DEPT. OF COMMUNITY
DEVELOPMENT
PLANNING DIVISION
301 W. CHESTNUT
PHONE: (479) 621-1186
FAX: (479) 986-6896

**PLANNING COMMISSION MEETING AGENDA
SEPTEMBER 20, 2022**

DRAWN BLL
CHECKED JMD
DATE July 27, 2022
PLOT SCALE NONE
JOB NO. 1035
SHEET UTILITY PLAN
C1.2

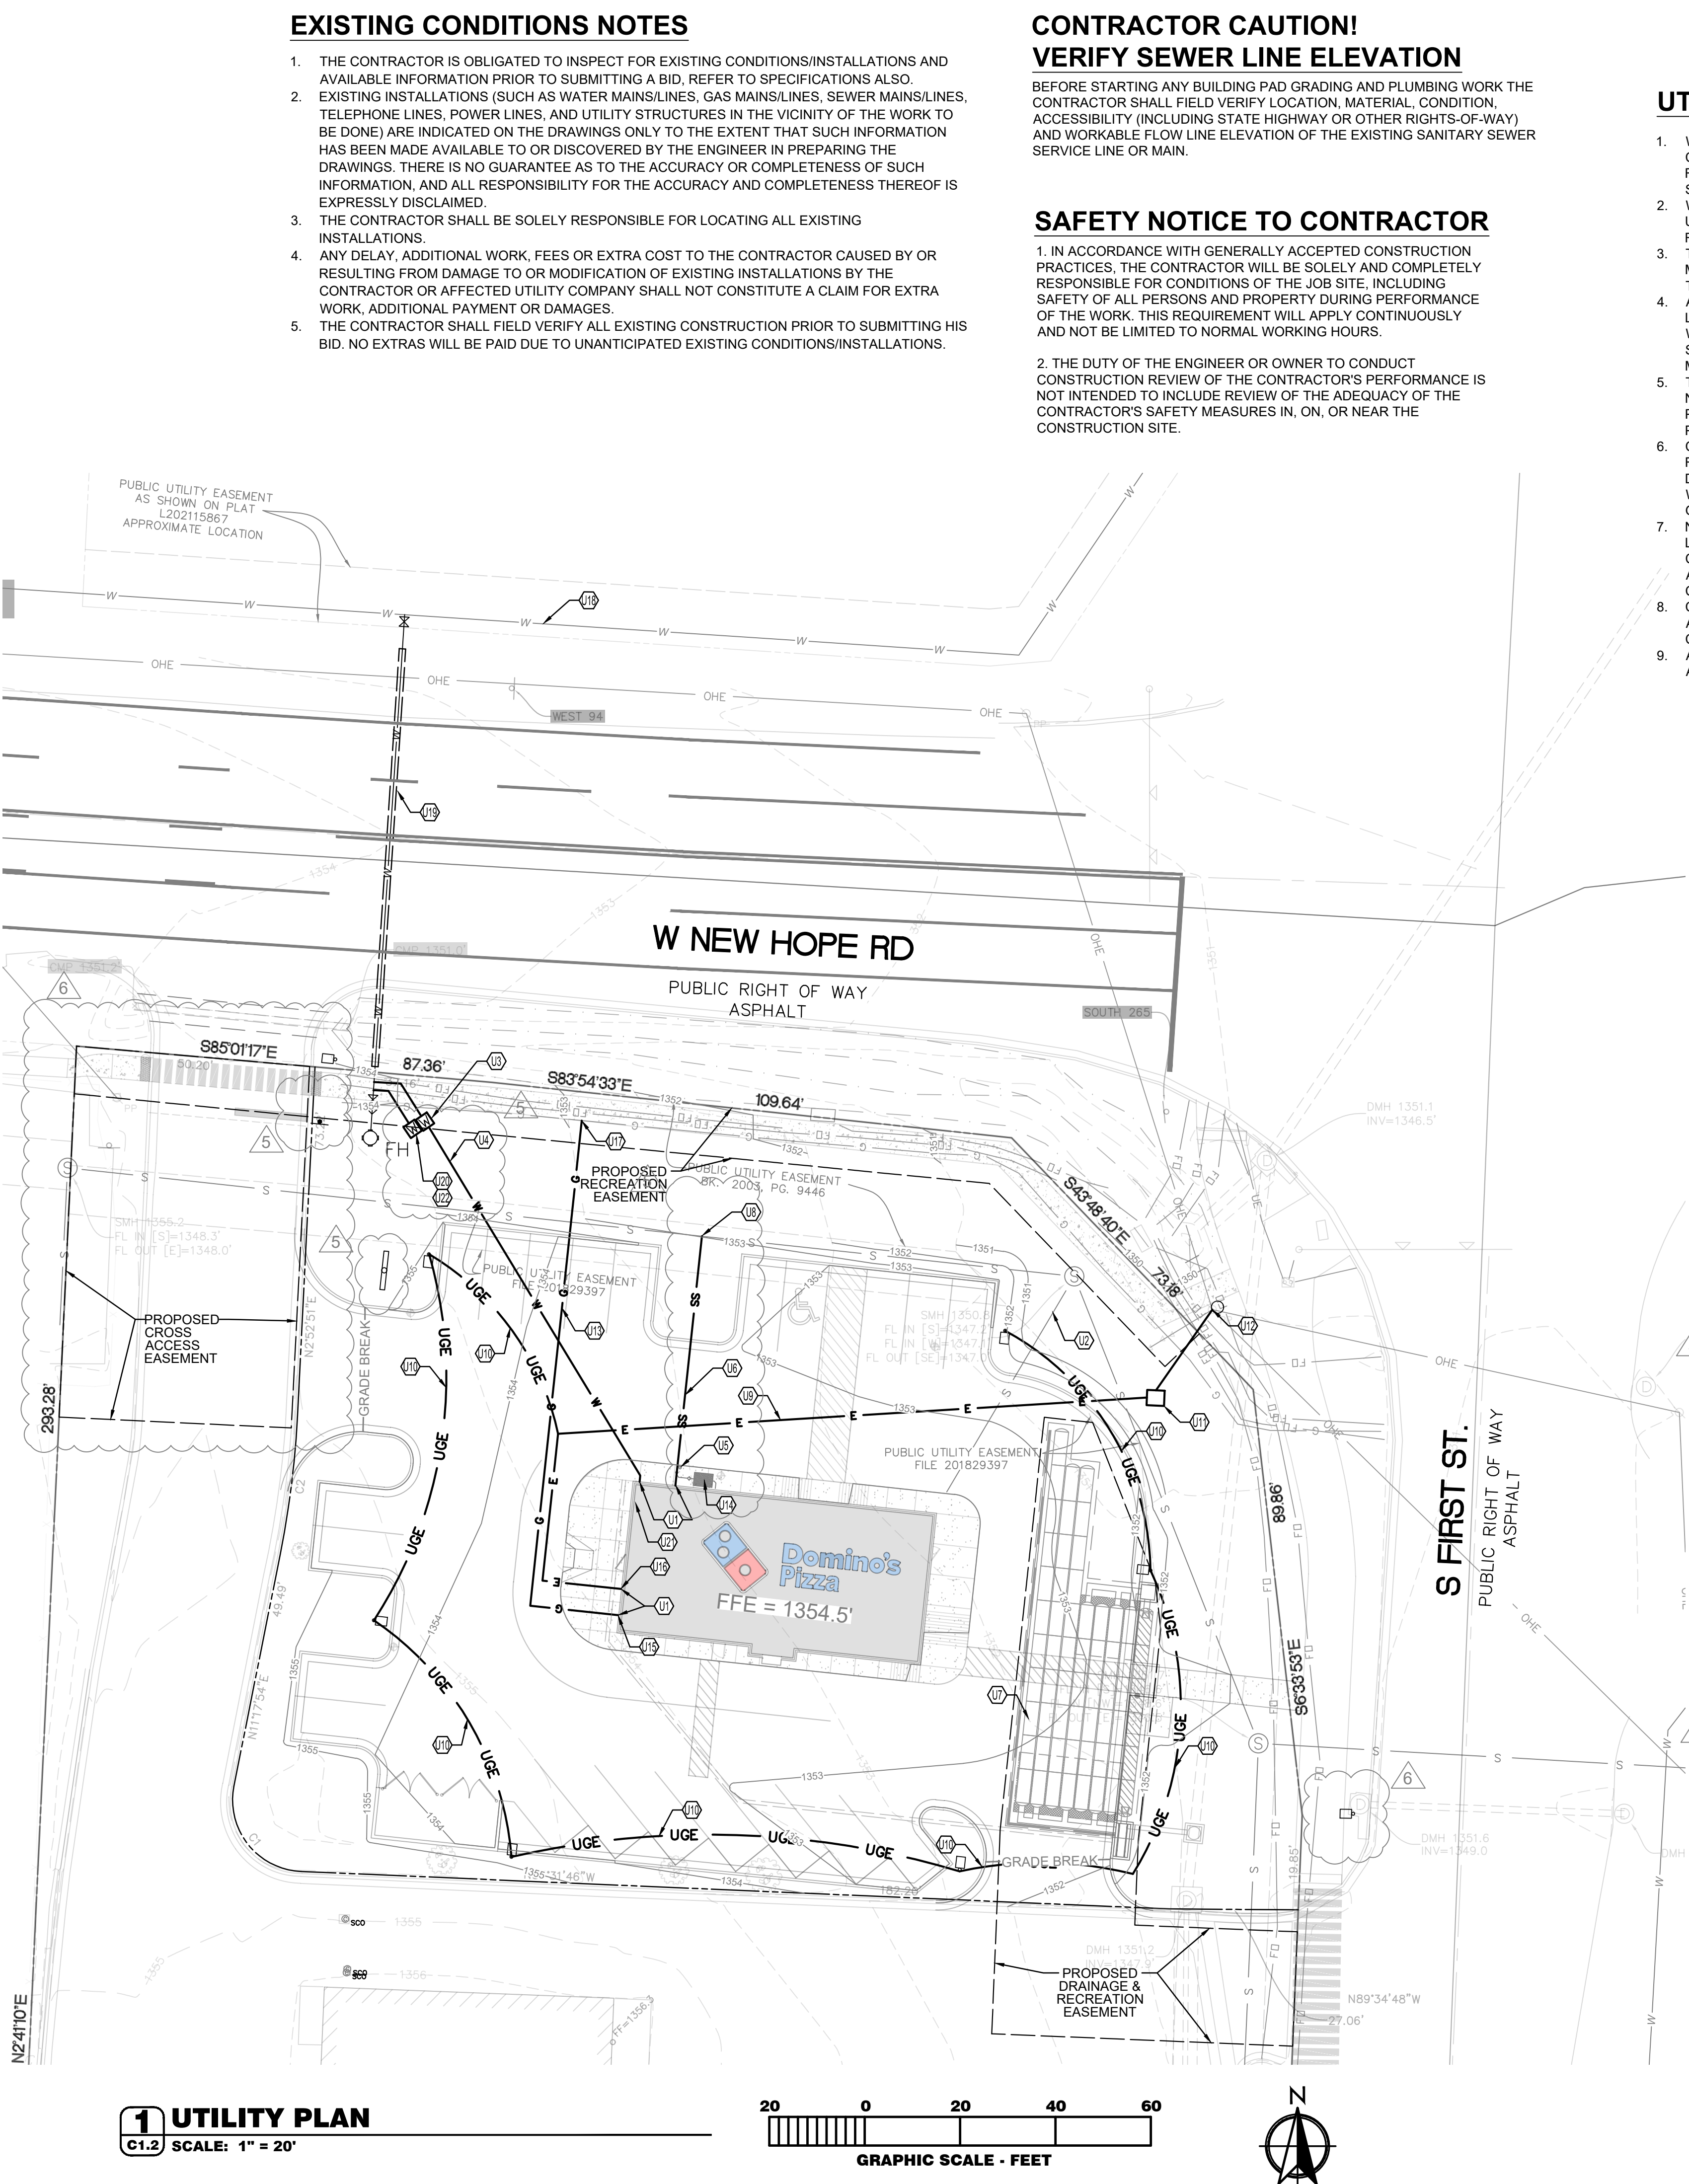
We have reviewed the plans that were received for the referenced project and are approving them for construction.

1. The following must be submitted prior to scheduling a pre-construction meeting:
 - A. The utility contractor must be licensed by the State of Arkansas in the Underground Piping, Cable, Trenching, Boring Specialty Class or as a Municipal Utility Contractor. A copy of the contractor's license must be submitted if the contractor has not worked recently within the Utility's service area.

- B. Written approval from the Arkansas Department of Health.
 - C. Architectural and plumbing plans submitted for commercial customers.
 - D. An executed copy of the Facilities Extensions Contract. Revise the document form with project specific information by replacing the blanks and bracketed phrases with pertinent information. Return the revised document, with supporting attachments, to RWU for review before having your client sign the agreement. Leave the "Track Changes" feature turned on for our review.

- G. Two full-sized copies and one half-sized copy of the approved plans submitted at the pre-construction meeting.

1 SITE LAYOUT PLAN

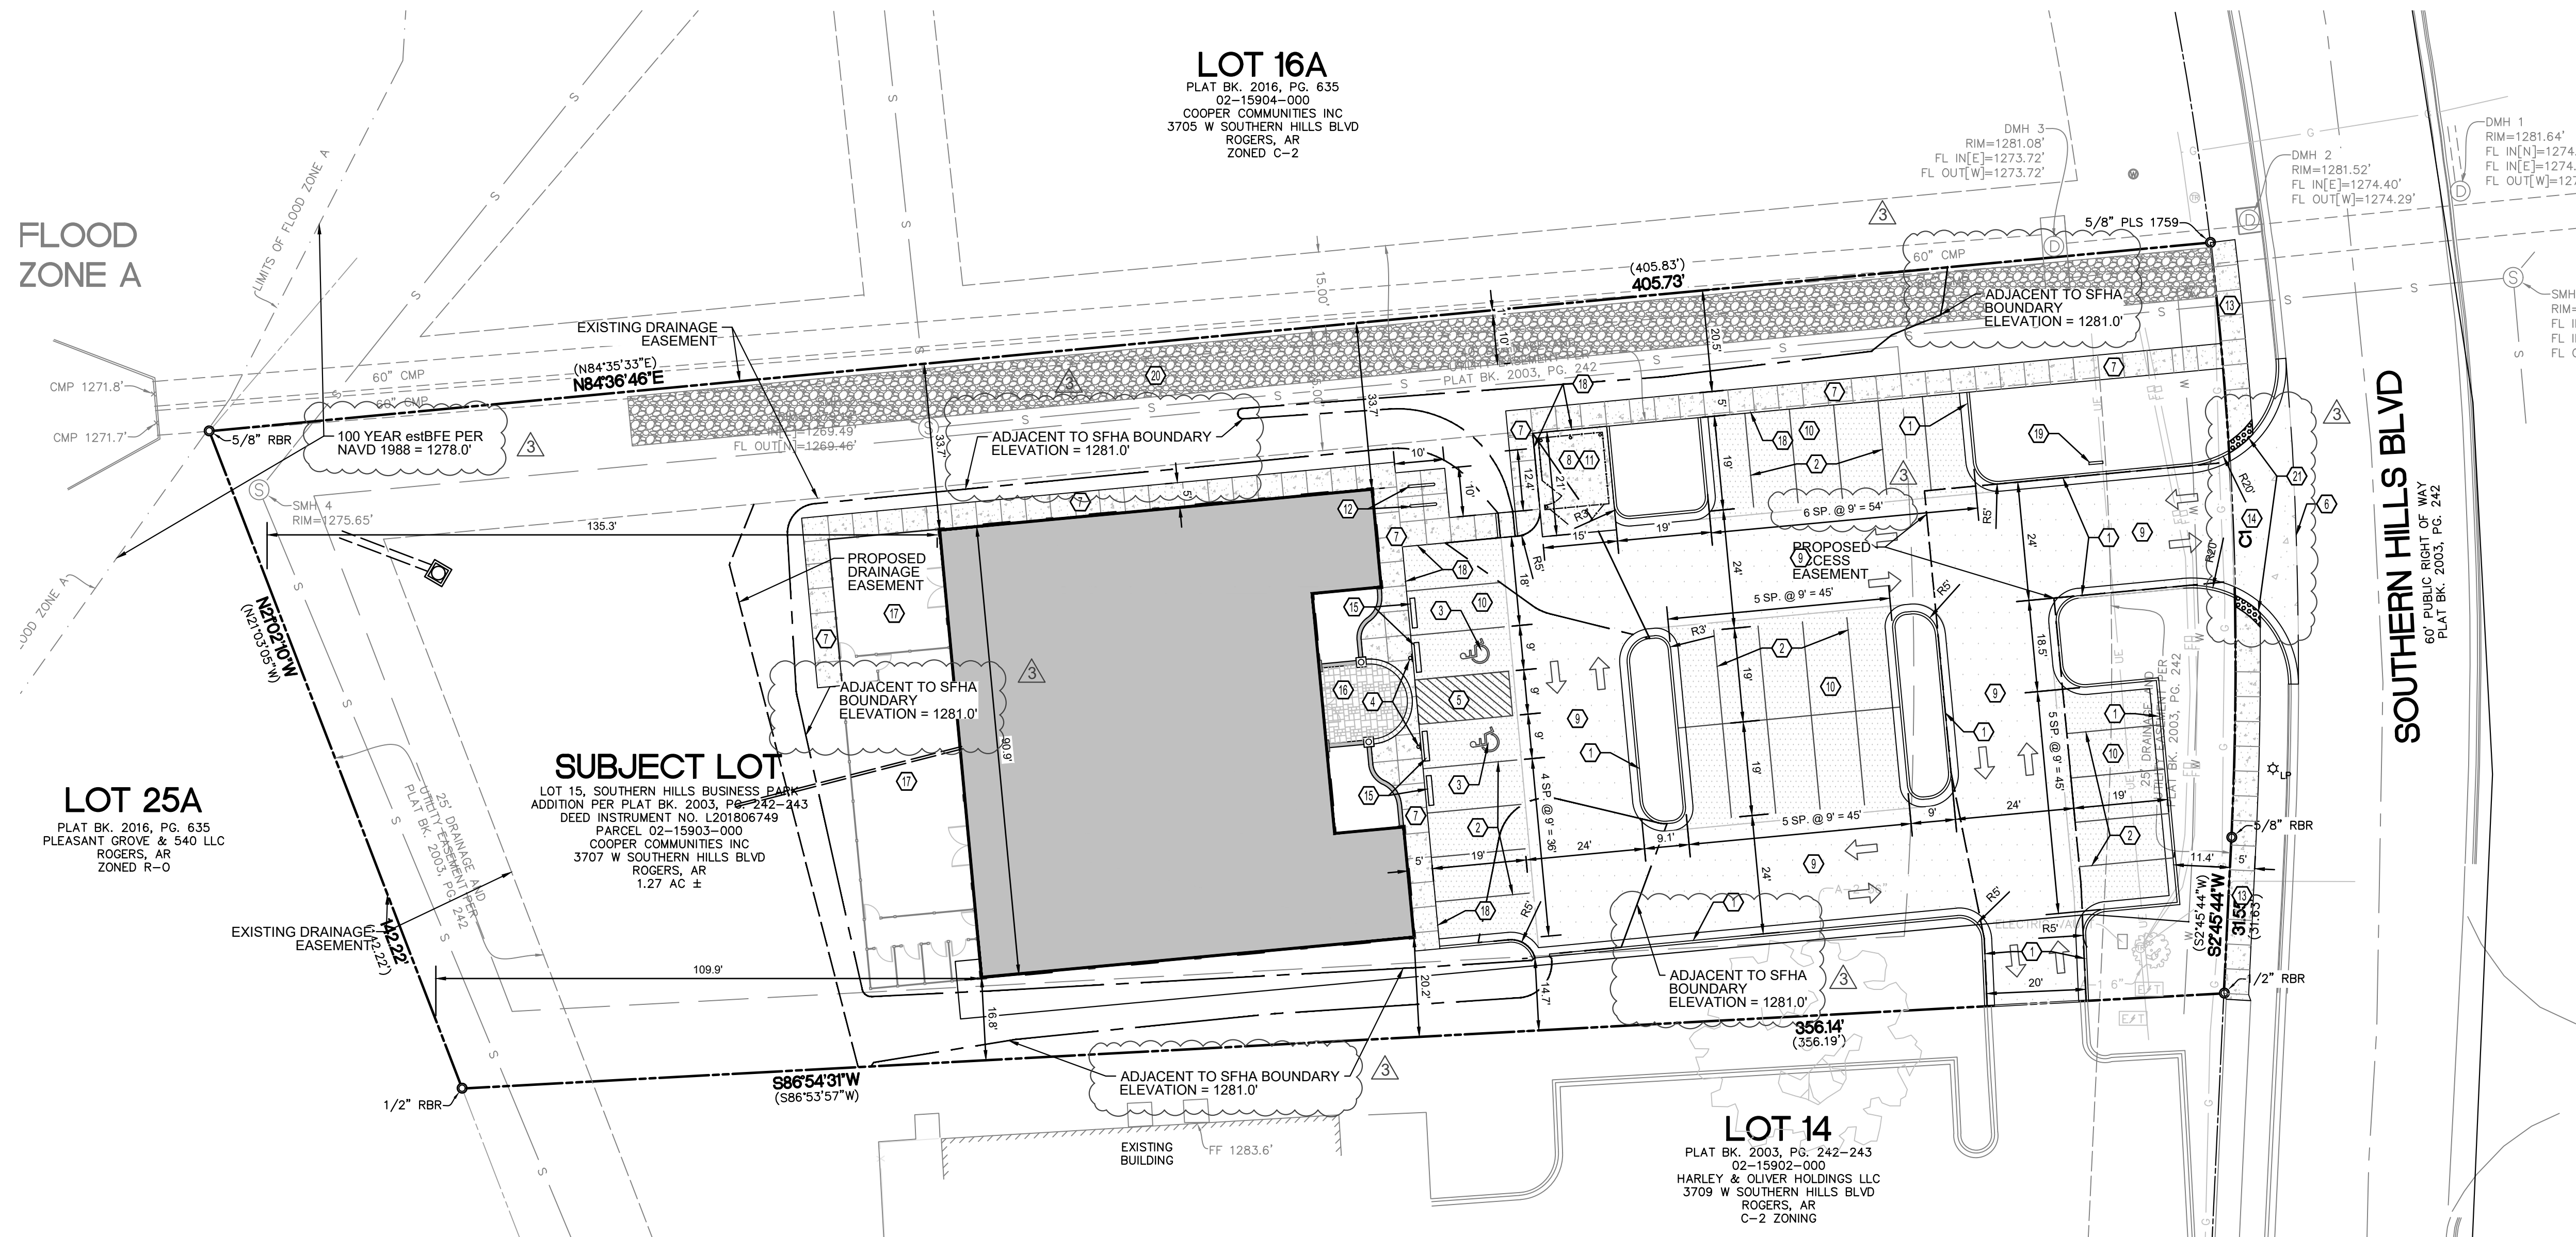
We have reviewed the plans that were received for the referenced project and are approving them with the following conditions:

1. Show the existing water meter that will be abandoned on the Utility Plan.
2. According to our records there is an existing sewer service stubbed out of the existing manhole north of the building. Verify the service enters the manhole and connect to it instead..
3. As per previous comment #6, move the proposed domestic water meter closer to the main to reduce the public portion of the service line.
4. The detail referenced in Utility Key Note U17 appears to be incorrect.
5. As per previous comment #3, show the fire line on the profile up to the backflow preventer.
6. Move the fire line demarcation valve to the location of the tapping sleeve.
7. Show the underground electric crossing on the fire line profile.
